Reference: Copperwood Stage 2 TIA – Comment Responses

**COPPERWOOD STAGE 2
TRANSPORTATION IMPACT ASSESSMENT**

DAYTONA URBAN DEVELOPMENT CORP.
City of Lethbridge RELD
COPPERWOOD STAGE II OUTLINE PLAN

Figure 3.4
Crossings TIA Full-Build Volumes
Copperwood Removed
PM Peak Hour

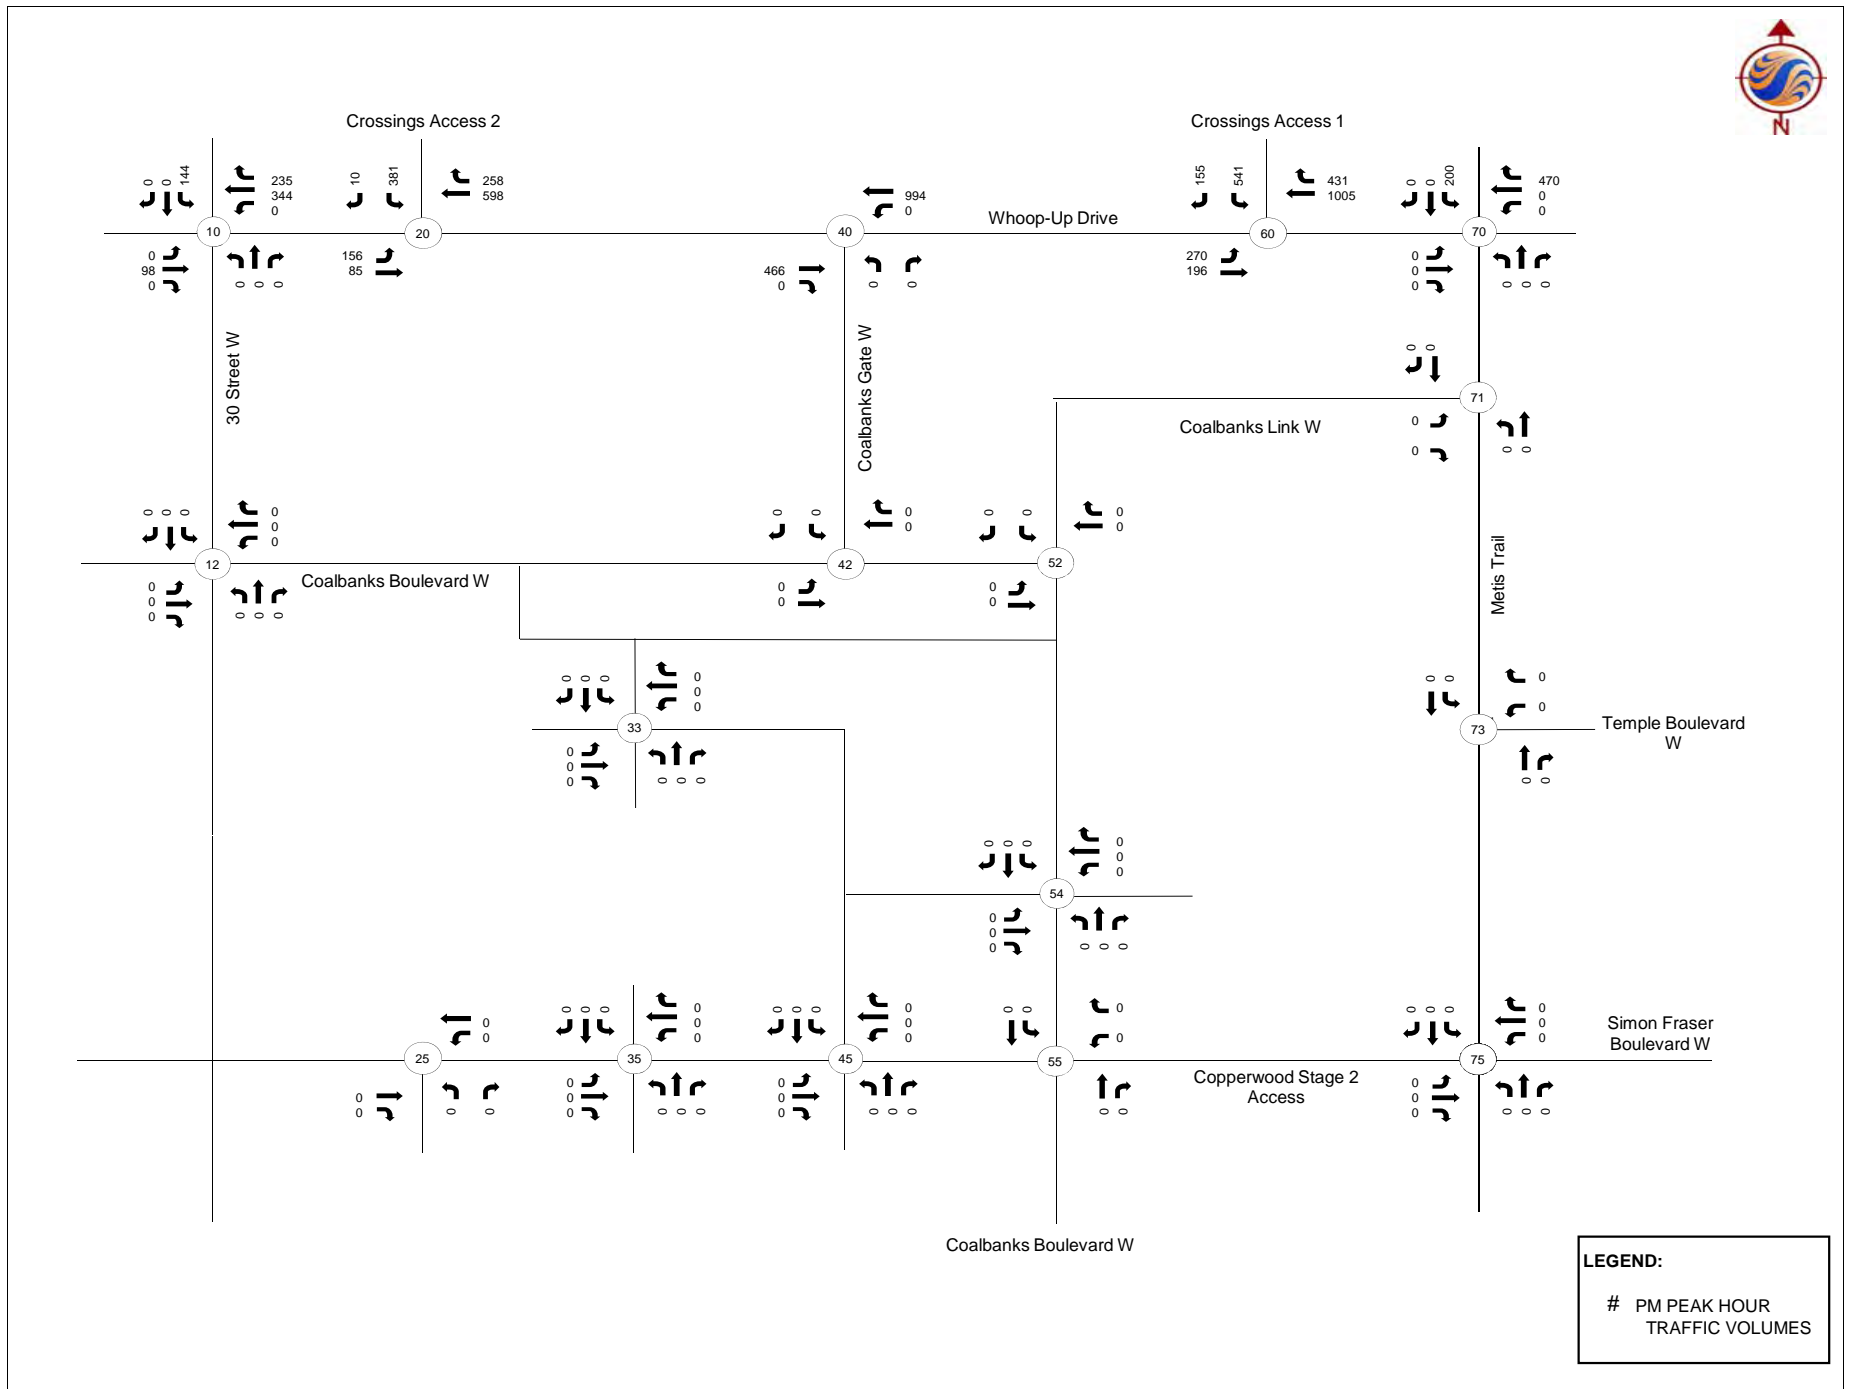
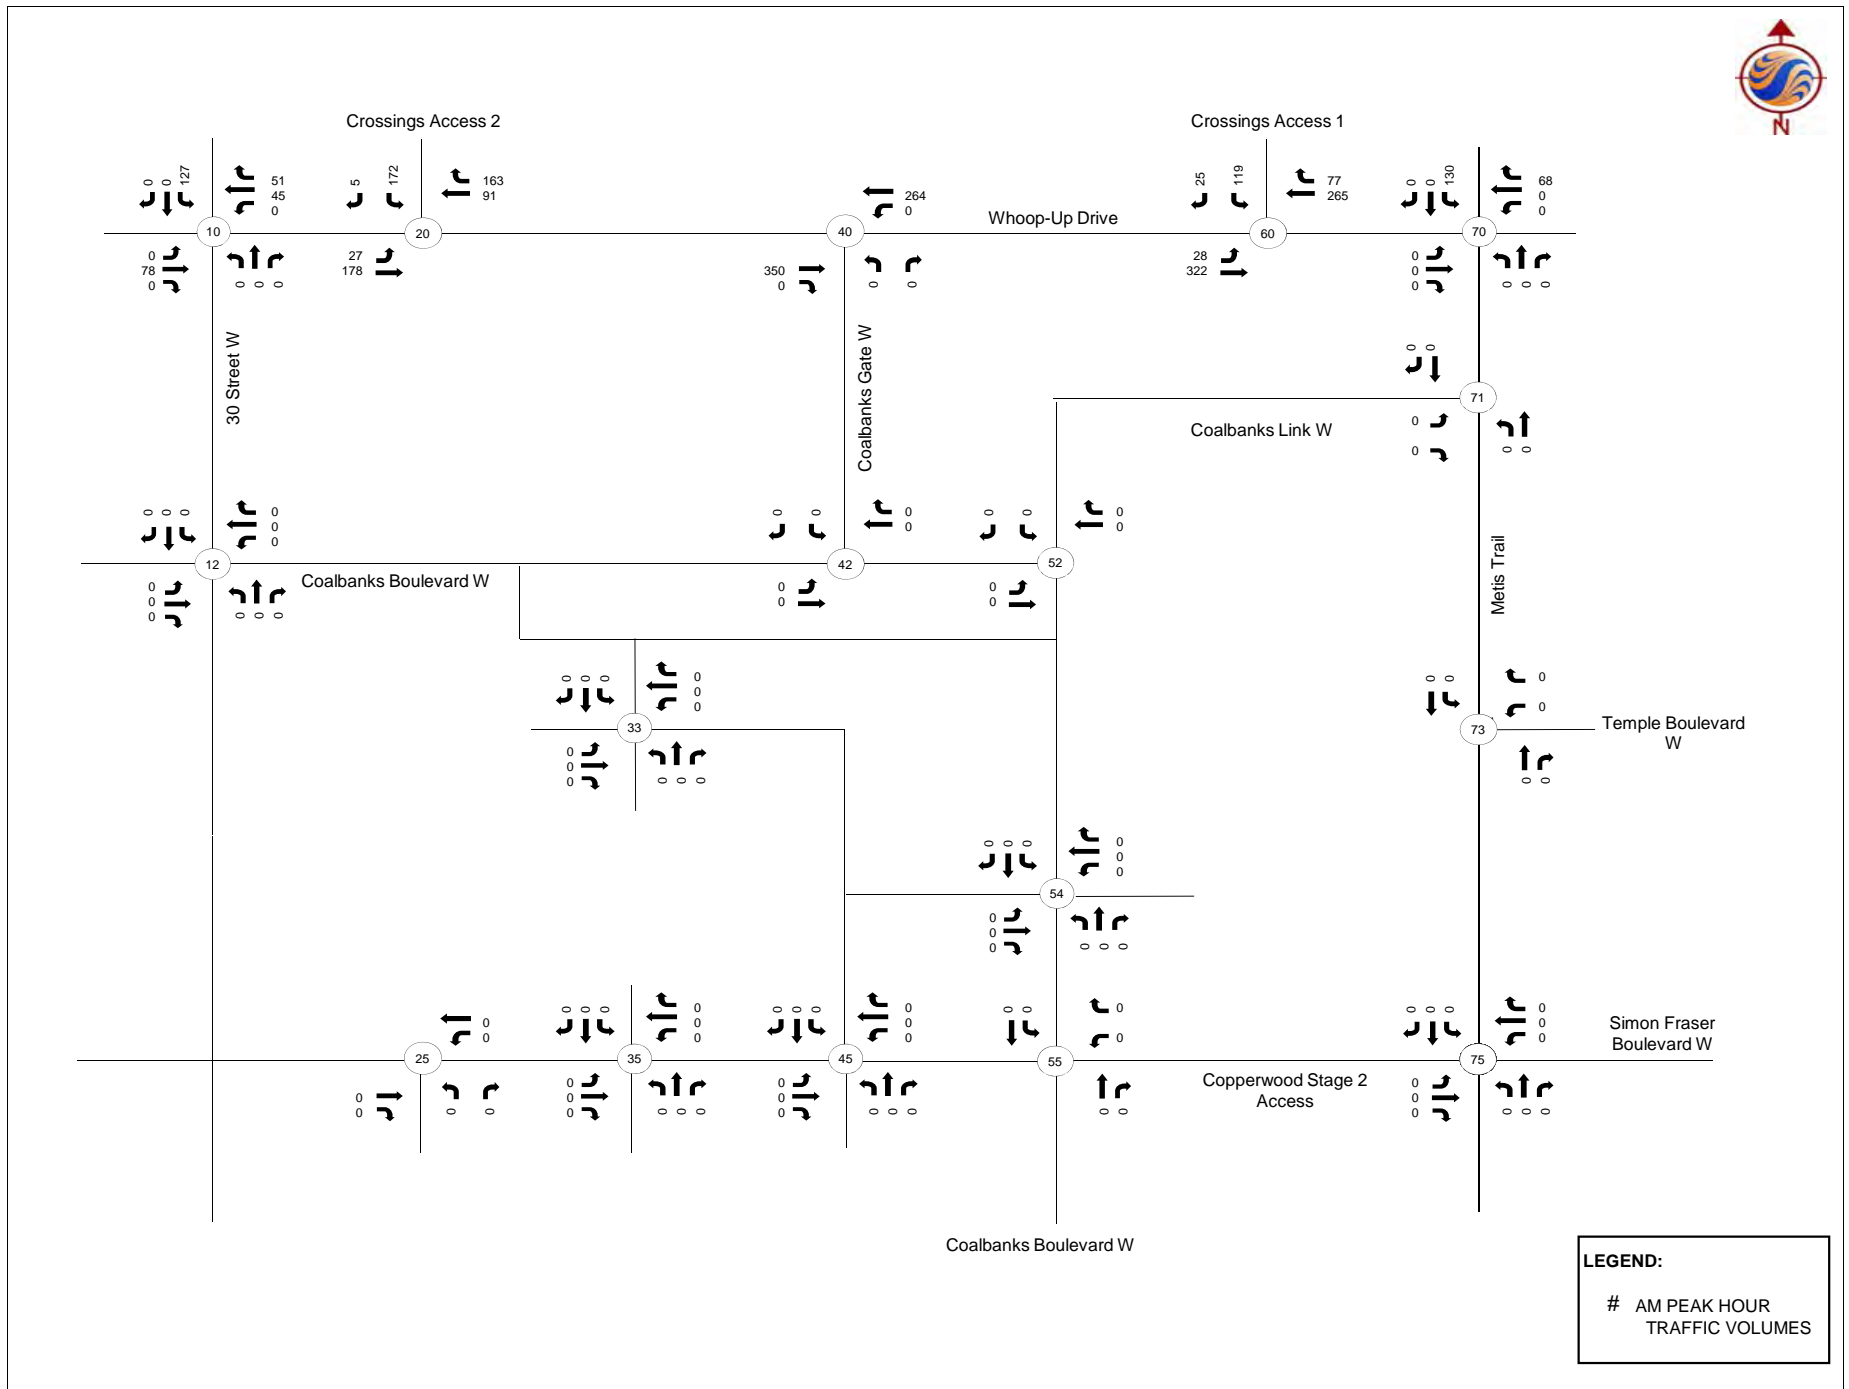
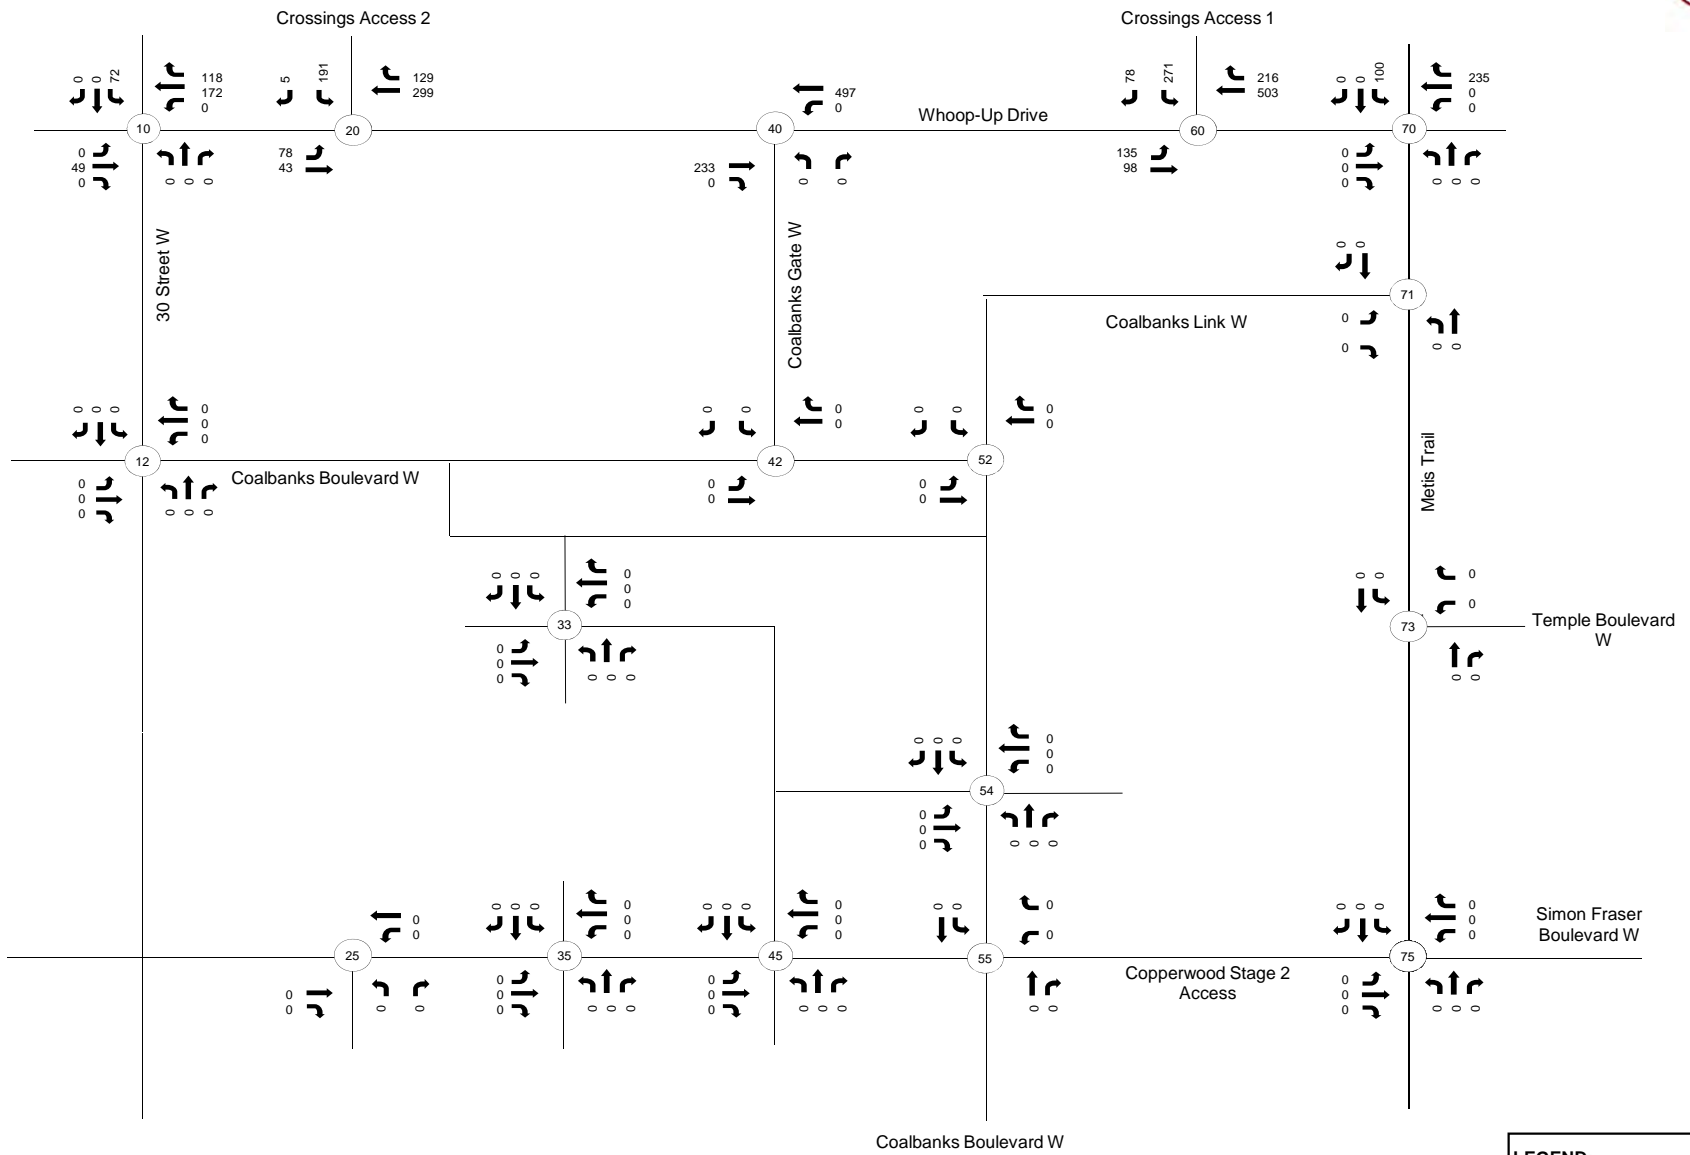
3. City’s Comment: *Figure 3.1 to 3.8 – Traffic volumes do not add up at Whoop-up Dr / Metis trail (Intersection 70), please check.*

Response: Figures 3.1 to 3.10 include information obtained from other studies (specifically the Crossings TIA – iTrans, July 2007; and the original Copperwood TIA – UMA, December 2005). These studies did not include volumes at the intersection of Whoop Up Drive / Metis Trail (Intersection 70) and therefore Figures 3.1 to 3.10 also did not include volumes at this intersection.

These volumes have been added to the updated report and are reflected in Figures 3.11 and 3.12 (background traffic volume), as well as Figures 3.15 and 3.16 which use the volumes from Figures 3.11 and 3.12 as information. The analyses for the background and post-development horizons have also been updated to include these volumes.
